Letter of Clarification No. 2

Chemical Storage Tanks for Public Works and Engineering

Invitation to Bid No.: S23-N23502

### 2.0 Chemical Building Drawing and Picture of Fluoride Tank (See Section BB)

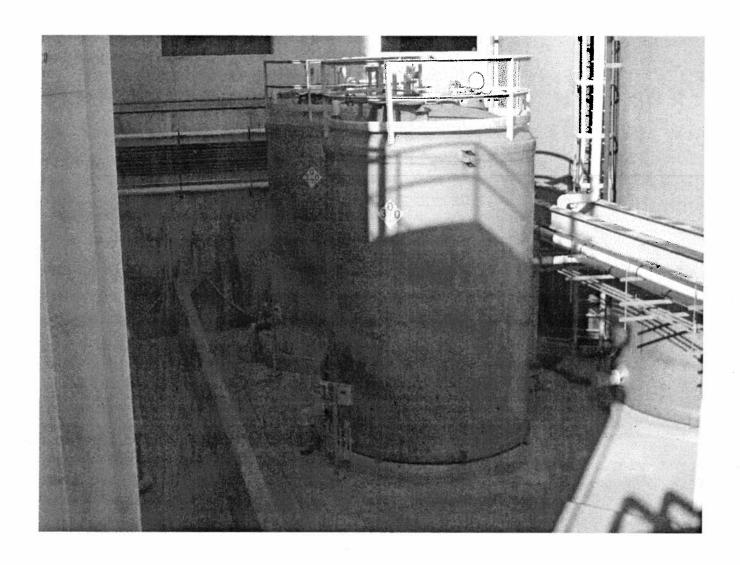
What is defined as "installation" for Item 3. Offloading the tank at the jobsite is one thing, installation could mean anchoring the tank to a foundation, piping, etc. There isn't a scope of work for that type of service.

- 2.1 See attached drawing for reference only; "New Fl2 Tank for location of existing tank. The elevation of the pad is around 17' with street approximately 32'.
- 2.2 The Distance from the curb to the center of the tank is approximately 90'.
- 2.3 The Drawing on the following pages can also be found on the e-bid website.

Please see page 16 of 27 marked revised 2/12/2010 herein which contains installation details and you are strongly encouraged to view the site conditions as noted on page 5 of 27 marked revised 2/12/2010.
